MEMORANDUM

REVIEW TYPE: Site Plan Review
APPLYING FOR: Approval of 83 MPDU multifamily Elderly Apartments on 4.66 acres
PROJECT NAME: Randolph Manor
CASE #: 8- 03013
REVIEW BASIS: Sec. 59-D-3, M. C. Zoning Ordinance

Site Plan
 Randolph, MA

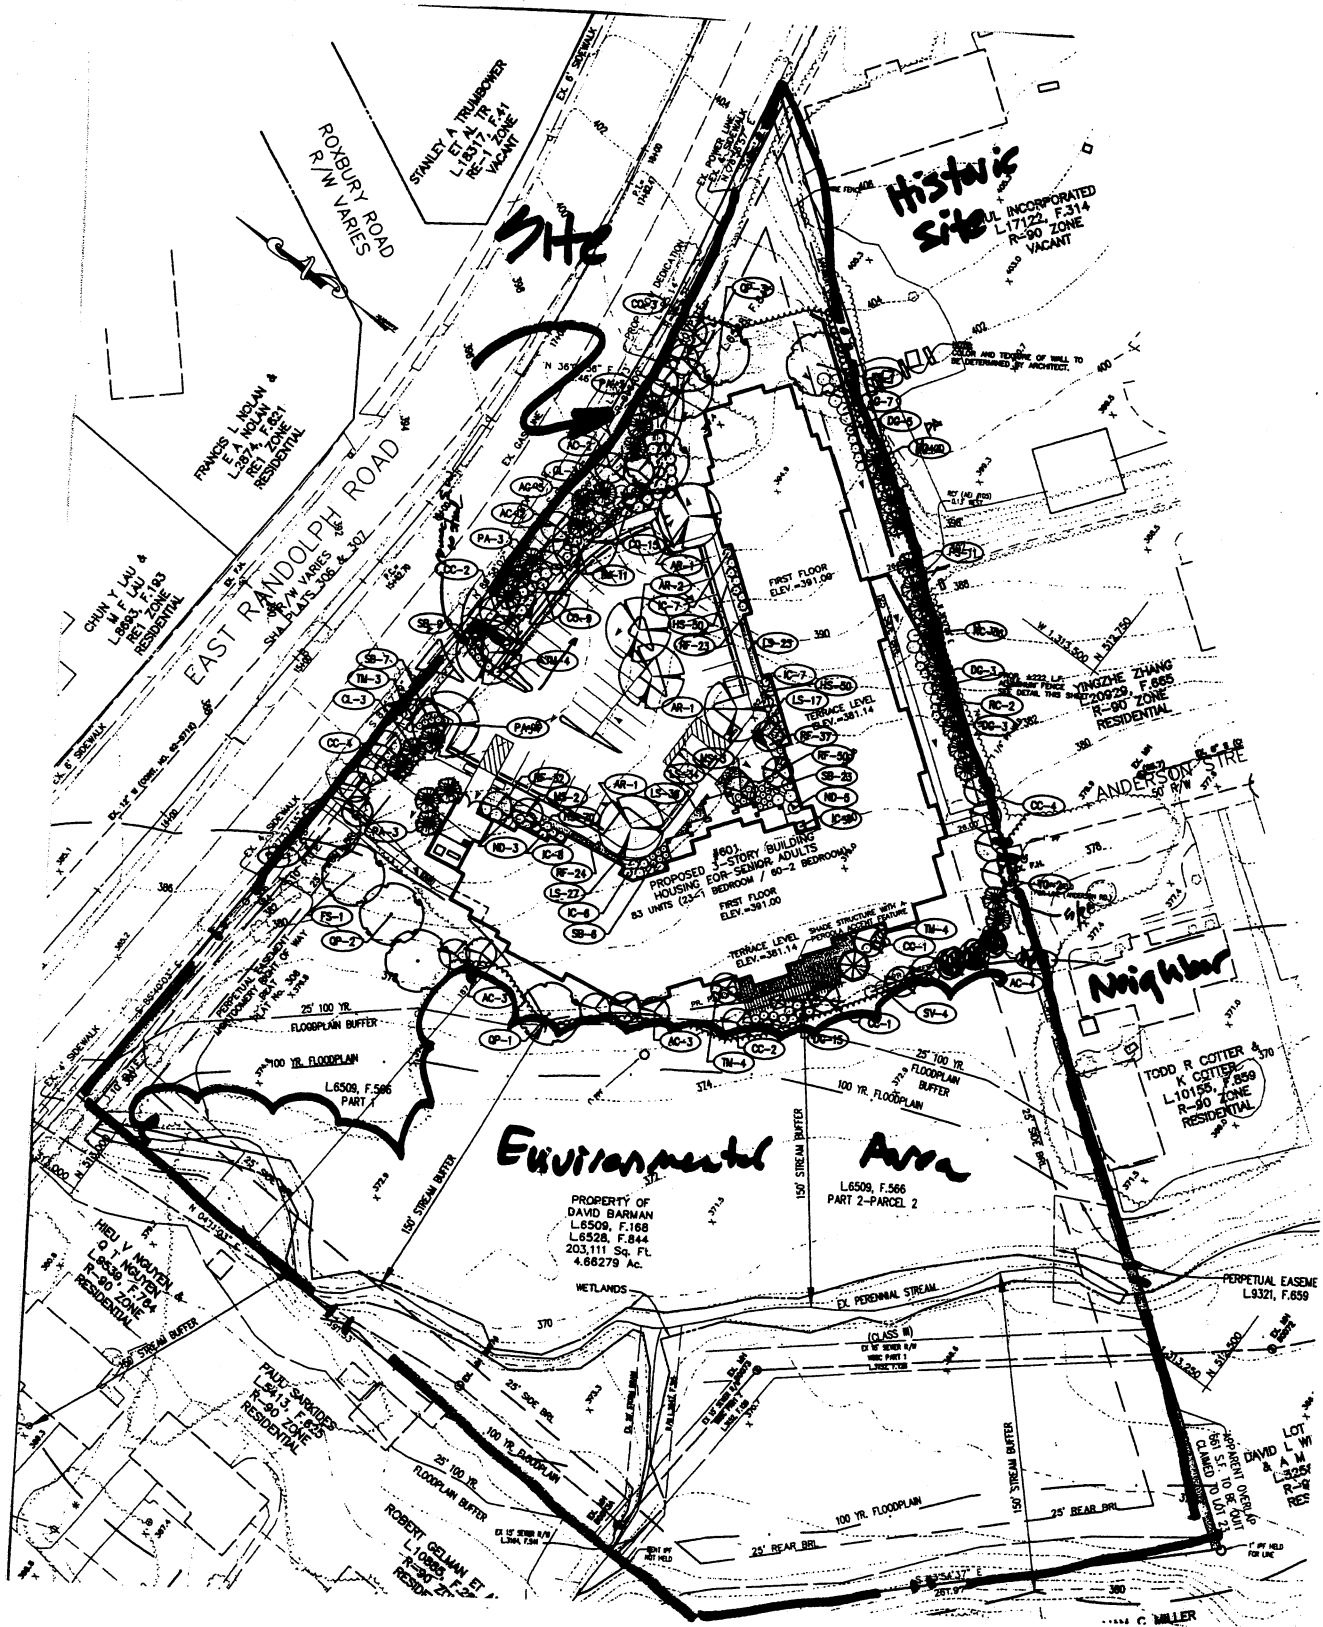
F. Provision of final recreation analysis for staff review to show conformance with the elderly requirement in the Recreation Guidelines.

G. Provision of final site and landscape plan to include the sidewalk connection to Randolph Road along the east side of the entrance for staff review prior to signature set approval.
